MEMORANDUM

From:	JP		
Service	WBC Highways	App No:	252518 and 252519
Address:	Pavement outside, 25 Peach Street, Wokingham.		
Proposal:	252518 – Full application for the proposed installation of 1 no. BT Street Hub and removal of existing telephone booth. 252519 – Application for advertisement consent for the proposed installation of 2 no. internally illuminated digital LCD display screens on either side of the BT Street Hub unit.		
Type of Development:	252518 – Minor All other developments 252519 – Other Advertisements		
Site Visit Made:	Yes/No

Comments On Proposal

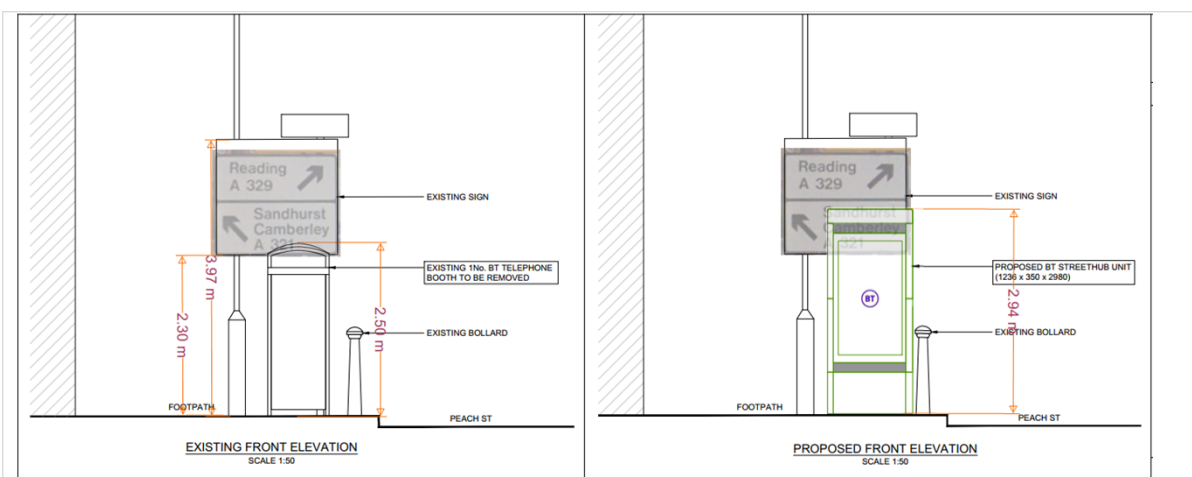
Drawing 003-A provides details on the existing and proposed elevations. While the dimensions in site photo cannot fully align with existing road sign on the submitted drawing, the Highways try overlaying the details to visualise the concern. The annotated proposed front elevation below indicates that the proposed BT Street Hub unit will block a significant portion of the existing road sign and worsen the existing condition.

Whilst it is acknowledged that the direction sign has been partially blocked by the existing telephone booth, the proposed Street Hub unit will be positioned circa 12m closer to the driver's direction of travel. This will steepen the required upward viewing angle of the drivers, even if the proposed height of the Street Hub were to remain at 2.5m.

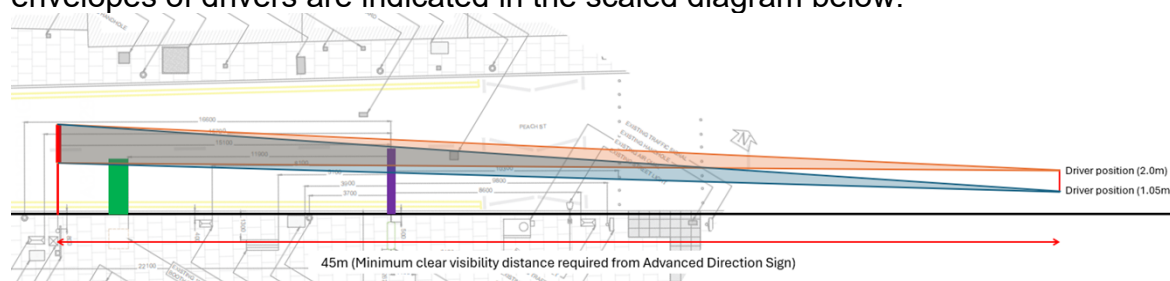
The appellant has been advised to demonstrate this forward visibility for vehicles travelling along Peach Street in both lanes, or the existing vertical visibility plane from driver position can be fully retained ranged from 1.05m (for car drivers) to 2m (for lorry drivers), which is still not assessed in the appeal.

The Highways, therefore, produce a section drawing and examine the visibility envelopes of drivers are indicated in the scaled diagram below:

The appellant has also been advised to reconsider either reducing the height or repositioning the Street Hub to behind the Advance Direction Sign, but this has not been considered.

The proposed position and height of the Street Hub will likely lead to a detrimental impact on highway safety, which is therefore unacceptable.
